Appl. No. ZB-9/20 + SP-11/20

SUBJECT: Use and Bulk Variance Application No. ZB-9/20
Major Site Plan – Preliminary & Final Approval Application No. SP-11/20
Mitch Brown, Circle Management, Inc., 1652 Princeton Avenue
Tax Map Page 1, Block 103, Lots 66, 67 and 68

Re: **Mitch Brown - Circle Management, Inc.**
Floor Area Ratio and Bulk Variances
Preliminary and Final Major Site Plan
Block 103, Lots 66, 67, and 68
1652 Princeton Avenue
Neighborhood Center 1 (NC-1) District
Application No. ZB-9/20

Proposed Building Front Façade

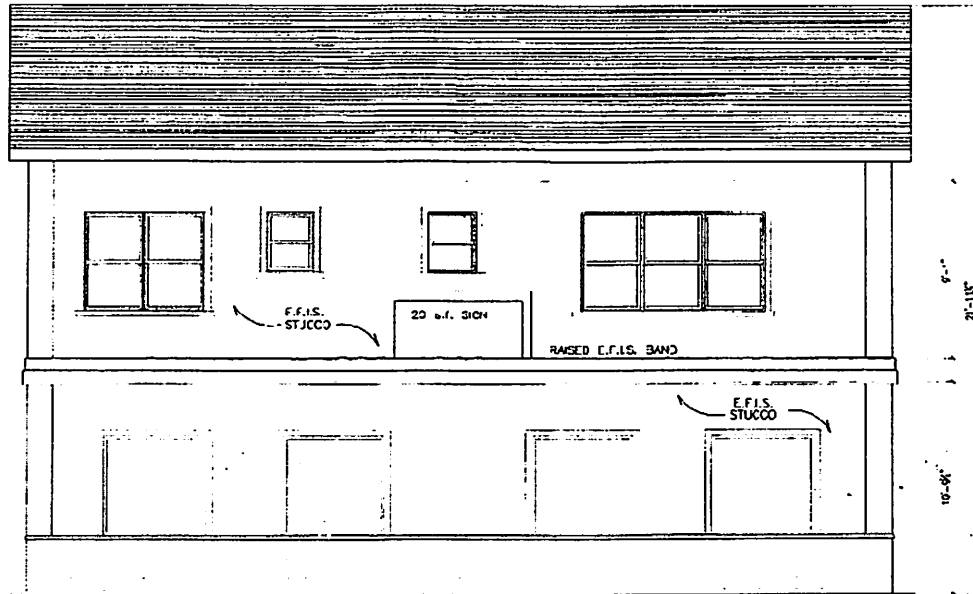
- 7.1 Proposed Elevations. The proposed facades of the building reflect a commercial design intent. On Princeton Avenue, which the long side of the building faces, there is a mixture of commercial and residential buildings. The residential buildings are typical of the post-World War I era with brick first stories and porches, with clapboard upper stories. In many instances the porches have been enclosed for more interior space with clapboard or other wooden material and traditionally painted white. The commercial buildings are all one-story excepting those that have been converted from residences and typically have flat roofs with a smattering of gable-roofed structures. Their facades are almost universally stucco and some have a base of masonry. The masonry bases are split face architectural block or stone veneer. Consequently, the proposed exterior materials proposed are consistent with the other commercial building on the Princeton Avenue corridor. Buildings should be compatible with neighboring areas through attention paid in the architectural design process to scale, size,

style, placement of doors and windows, its form, color, and exterior materials (§536.A.2). Here, the architect has created a base, middle and top to the building, as well as added an accent line to distinguish between the first and second floors. These components are recommended in the Township's commercial building design guidelines, and the gable roof is required for certain commercial buildings under 6,000 sf. in area. Consequently in our view, the exterior building design meets the ordinance standard.

- 7.2 Windows. There should be an attempt to standardize the windows in the façade among the residential and commercial floors. In the elevations that have been presented, two incompatible types are proposed.
